Bayside Planning Panel

Item No	6.8
Application Type	Development Application
Application Number	DA-2009/316/D
Lodgement Date	22 September 2017
Property	52 Clareville Avenue, Sandringham NSW 2219
Owner	Mrs Anastasia Susan Prapas and Mr Jim Prapas
Applicant	Mr Jim Prapas
Proposal	S96 (1A) Modification Application seeking to reduce lift overrun height, relocation of lift door to east side, addition of a colorbond roof to roof terrace and deletion of Condition 11a
No. of Submissions	Three (3)
Cost of Development	N/A
Report by	Adam Iskander – Development Assessment Planner

Section 96(1A) – Delegated Report

Application Number: DA-2009/316/D
Date of Receipt: 22-Sep-2017
Property: 52 Clareville Avenue, SANDRINGHAM NSW 2219
Lot 13 DP 5643
Owner: Mr J Prapas and Mrs A S Prapas
Applicant: Mr J Prapas
Proposal: S96 (1A) Modification Application seeking to reduce lift overrun height, relocation of lift door to east side, addition of a colorbond roof to roof terrace and deletion of Condition 11a

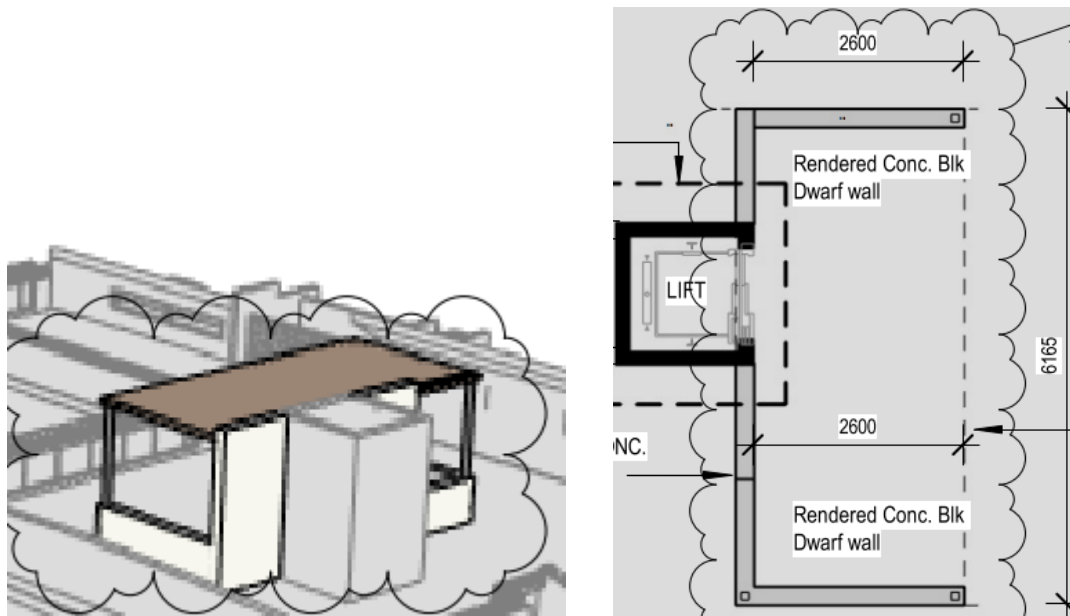
- Lift entry to face east (original plans proposed the entry to the lift faces west towards Clareville Avenue);
- Reduce height of covered area above lift from RL 14.554 to RL14.095 (a reduction of 0.459m)
- New covered area in front of lift providing shelter with dimensions of 2.6m x 6.165 creating a total floor space of 16.029sqm;
- The covered area will be constructed of rendered concrete walls. The rear walls will have a height of 2.645m with dwarf walls along the side and a colorbond roof over with a light to medium colour. The shelter will be an open structure from the front and partially along the sides;
- The height of the structure will be 2.770m;
- The images below show the proposed structure at a Birdseye view and a floor plan:

11b *The covered area attached to the lift on the roof top terrace shall be reduced in size. The northern dwarf wall shall be in line with the northern wall of the lift. The depth of the covered area attached to the lift shall be reduced from 2.6m to 2m.”*

Mellon Architectural and Building Services 9/83-85 Elouera Rd., Cronulla NSW 2230 0418 224 279 02 9544 3088 bus. 02 9383 8572 fax ross.karp@bigpond.com	Prapas House 52 Clareville Ave., Sandringham.	ROOF PLAN		
		Project number 08100		<div>16</div>
		Date	10/04/15	
		Drawn by	RAK	
		Checked by	rak

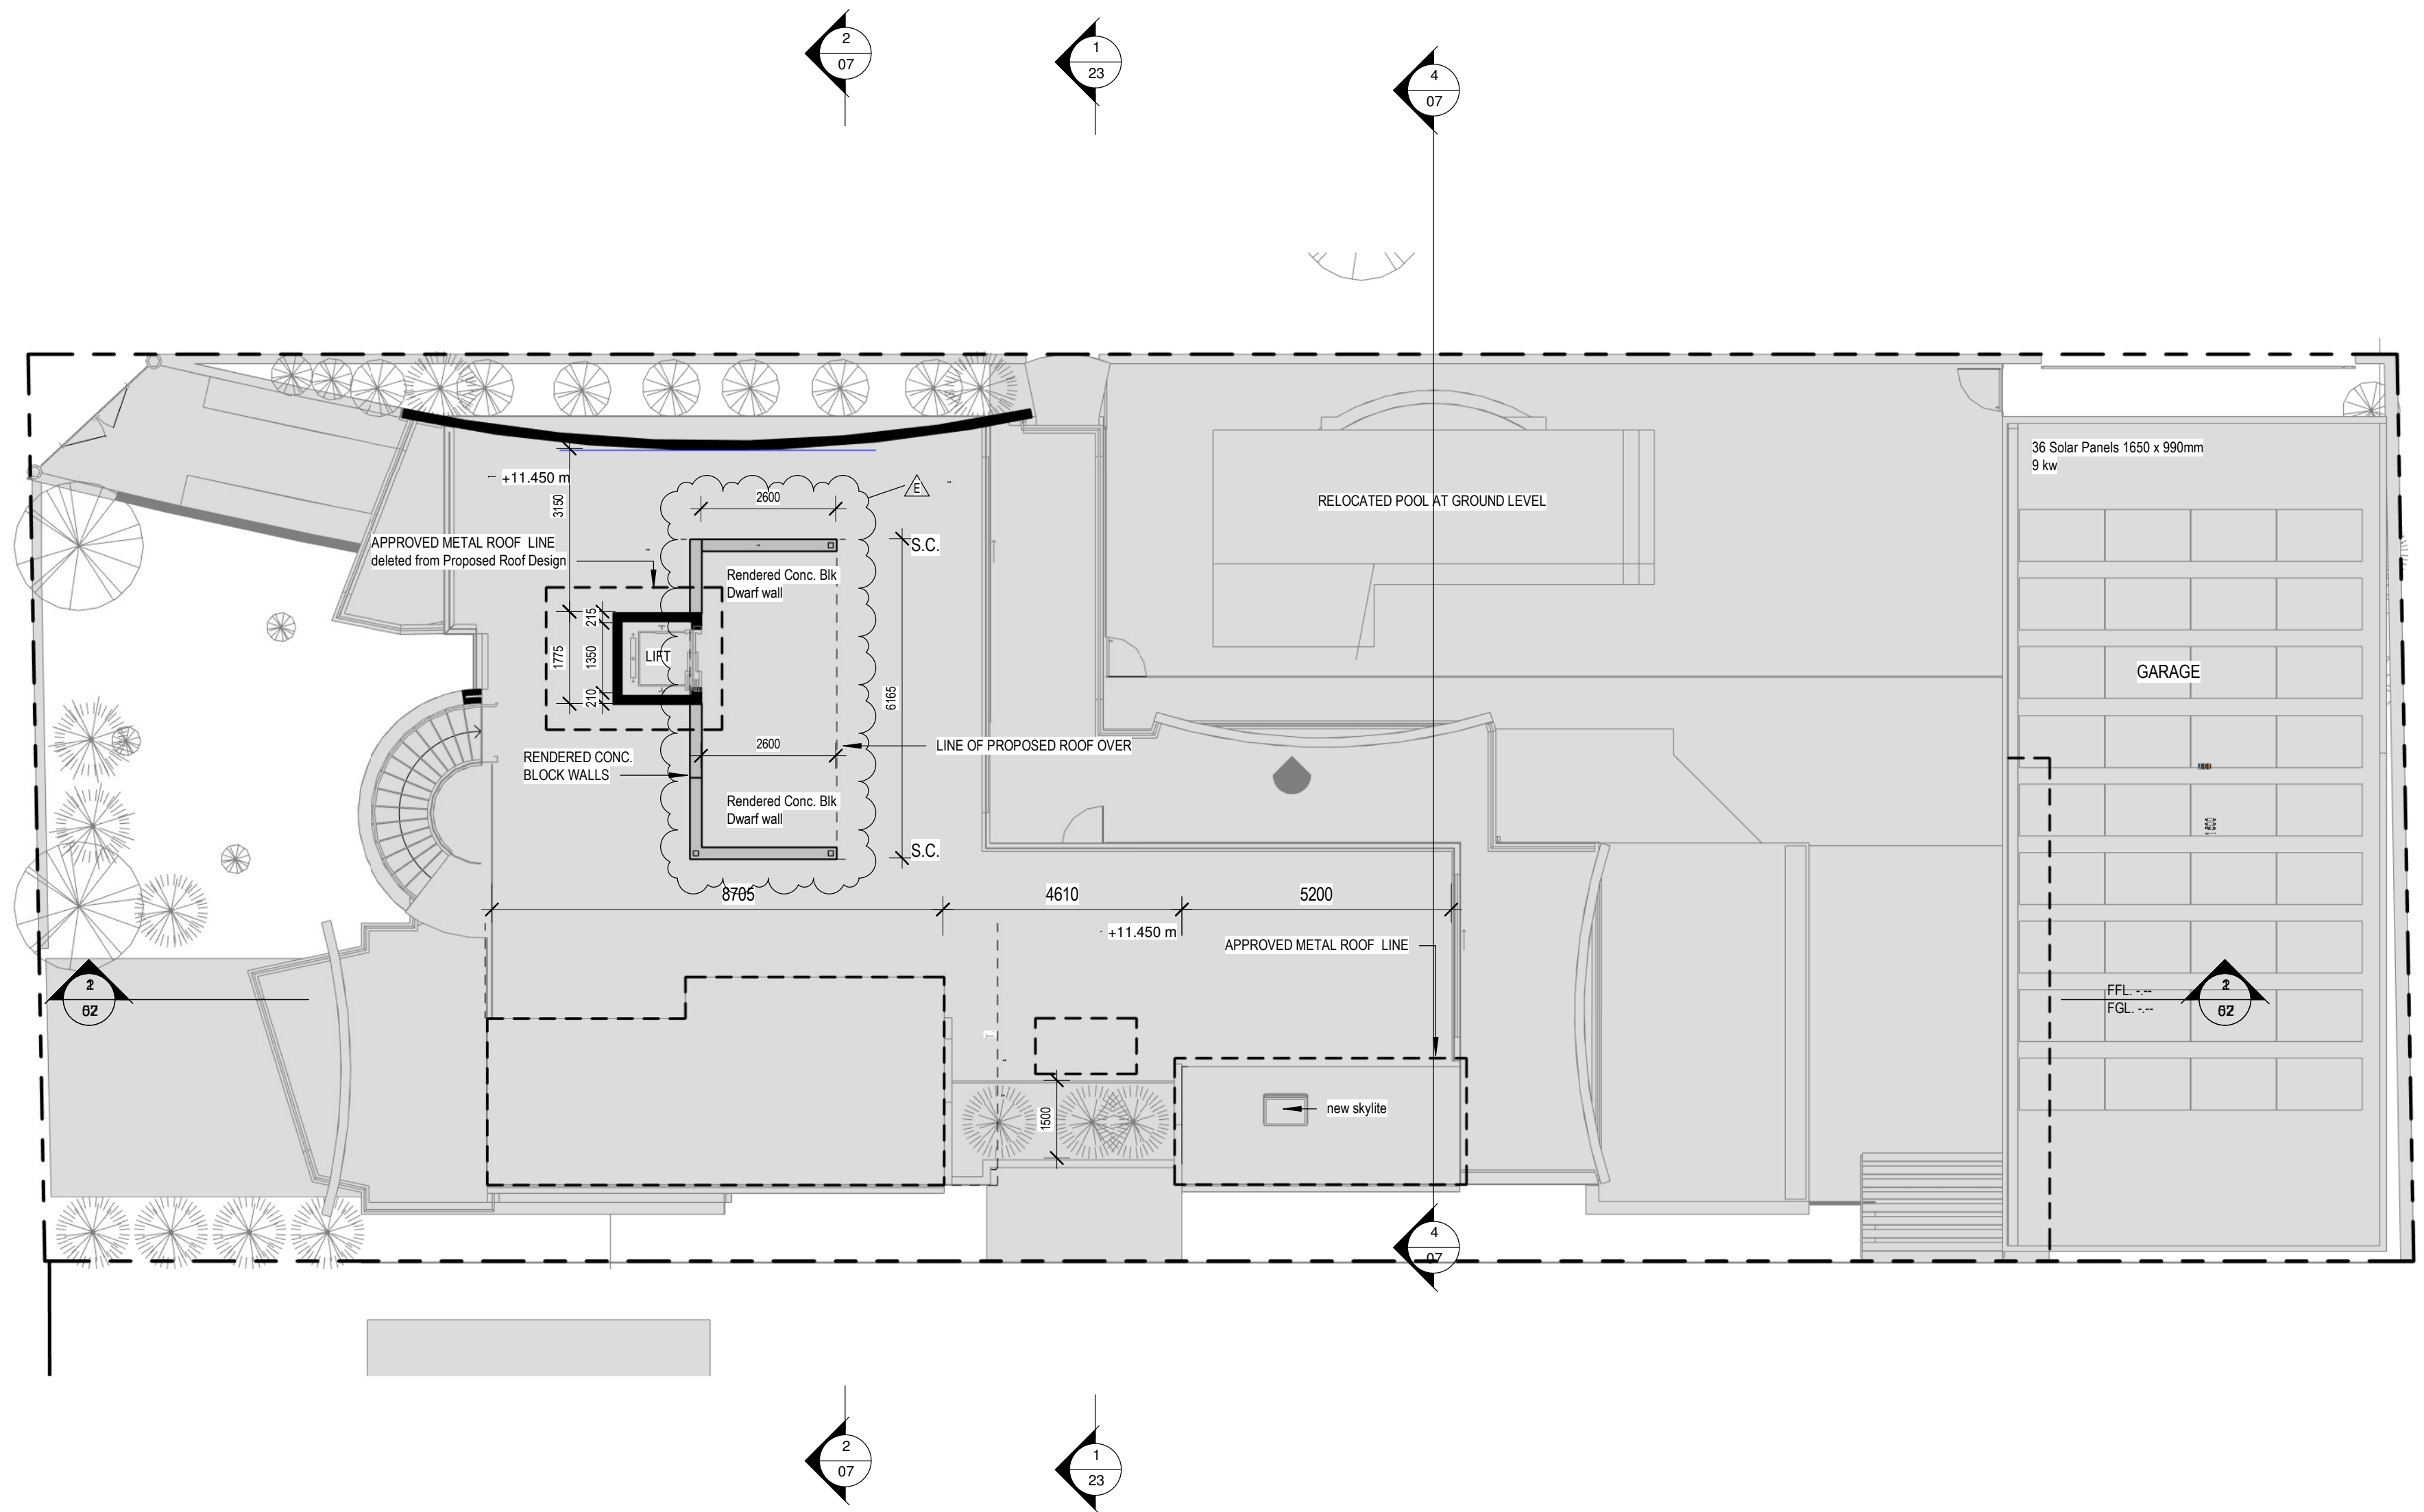
The application proposes no changes to the roof top terrace, only the access point. The proposed entry point will be of a lesser height to that which was originally approved under DA-2009/316.

Several concerns have been raised by the adjoining neighbours relating to non-compliance with privacy, bulk and scale.

The covered area in front of the lift is setback 10.5m from the southern boundary shared with 54 Clareville Avenue and a skillion roof is located along the southern side of the roof top terrace which will obstruct any direct over-looking to the southern neighbour when standing at the proposed entry point/lift. The neighbours to the rear and to the north (across Sanoni Avenue) are located at a long distance away from the proposed entry point. Issues relating to privacy and over-looking which have been raised by the neighbours are generally related to the roof top terrace which has already been granted approval under the original application DA-2009/316 and cannot be deleted with this S96 application. The proposed works satisfy Objective A of Part 4.4.5 of RDCP 2011 where the proposed works have been designed and sited to ensure visual privacy.

Issues relating to bulk and scale are not assessed as significant to warrant the deletion of the proposed lift and covered area in front of the lift. The structure is consistent with recent approvals in the area for roof top terraces. However, to lessen the perceived bulk of the development and to maintain consistency with recent approvals, the size of the covered area shall be reduced by way of condition. This reduction will also limit the use of the access point for entertaining. The condition will read as follows:

Setting the covered area attached to the lift away from the northern side of the roof top terrace will reduce its visibility from the Sanoni Avenue and will reduce the perceived impact of bulk and scale.

“The covered area attached to the lift on the roof top terrace shall be reduced in size. The northern dwarf wall shall be in line with the northern wall of the lift. The depth of the covered area in front of the lift shall be reduced from 2.6m to 2m.”
